Discussion of the Paper “SPE-187038-MS: Fracture Closure Stress: Reexamining Field and Laboratory Experiments of Fracture Closure Using Modern Interpretation Methodologies”

Mark McClure

ResFrac Corporation

April 15, 2019

Figure 2: Reproduction of Figure 6c from Craig et al. (2017). Tiltmeter measurements during reopening in Injection 4b from the MDX field demonstration project.

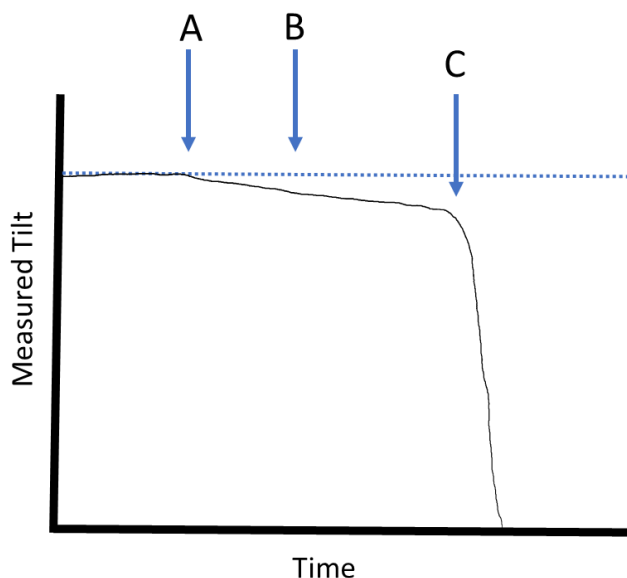
Because of how Craig et al. (2017) plot the data, interpretation is hampered by uncertainty regarding injection rate. However, even if we assume that injection rate is constant over time, the data does not support their conclusion. Because the paper is copyrighted, the figure is not reproduced below. Instead, the results have been reproduced from their Figure 6c by tracing over the curve with a stylus. The tilt is measured as 'negative' so the curve goes down as the crack opens. The figure from Craig et al. (2017) also shows the concurrent fluid pressure, but in Figure 2, only tilt is shown, for clarity. Figures 6a and 6b from Craig et al. (2017) are qualitatively the similar, and so are not reproduced.

There are two points with apparent deflection in tilt: Points A and C. Point A corresponds to 2500 psi, lower than the predicted reopening pressure from either the tangent or compliance methods. Point C corresponds to the point when pressure is equal to the closure pressure from Injection 4a, as interpreted by the compliance method (3200 psi). The fluid pressure at Point B corresponds to the reopening pressure predicted by the tangent method (2900 psi). After Point C, the tilt goes off the scale of the graph as the fracture opens further.

Craig et al. (2017) claim that the data in Figure 2 confirms the tangent method pick that stress is equal to 2900 psi (Point B). However, the curve is straight at Point B. The curve deflects at Points A and C. There is not a discernable deflection at Point B.

Fractures have roughness, and joints have a nonnegligible compliance and ability to store fluid, even when their walls are still in contact (Barton et al., 1985; Jaeger et al., 2007). Thus, some fluid will seep into the fracture prior to the full separation of the walls, followed by a much larger change in aperture once the walls fully separate. Point A corresponds to the point where nonnegligible amount of fluid seeps into the fracture (while the walls are still in contact). Point C may be the point corresponding to full separation of the fracture walls, but again, a true interpretation is impossible because of how the data is plotted.
